SUBJECT: NFPA 1970 (1971) Proposed TIA No. 1594 **FINAL TC BALLOT RESULTS**

NFPA 1971-2018 Edition

Standard on Protective Ensembles for Structural Fire Fighting and Proximity Fire Fighting

TIA Log No.: 1594

Test Method	Test Method Description	Test Method Application
	Exterior of Xenon Apparatus.	
	Interior of Xenon Apparatus in Use.

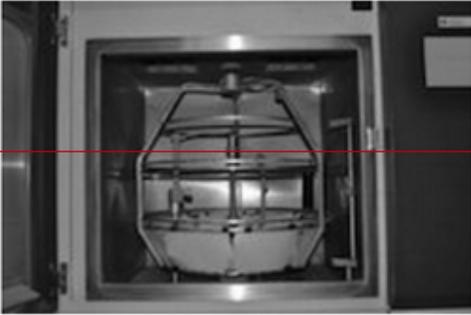
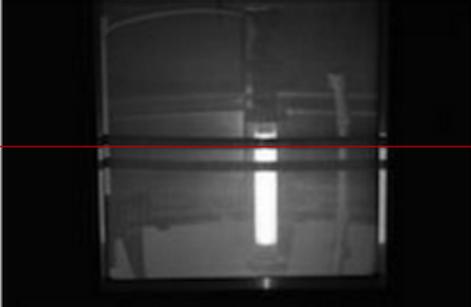
5. Delete the line entry 7.1.23, and photos for “Exterior of Xenon Apparatus” and “Interior of Xenon Apparatus in Use”, and update the cross references in Table B.2 Garments as shown here:
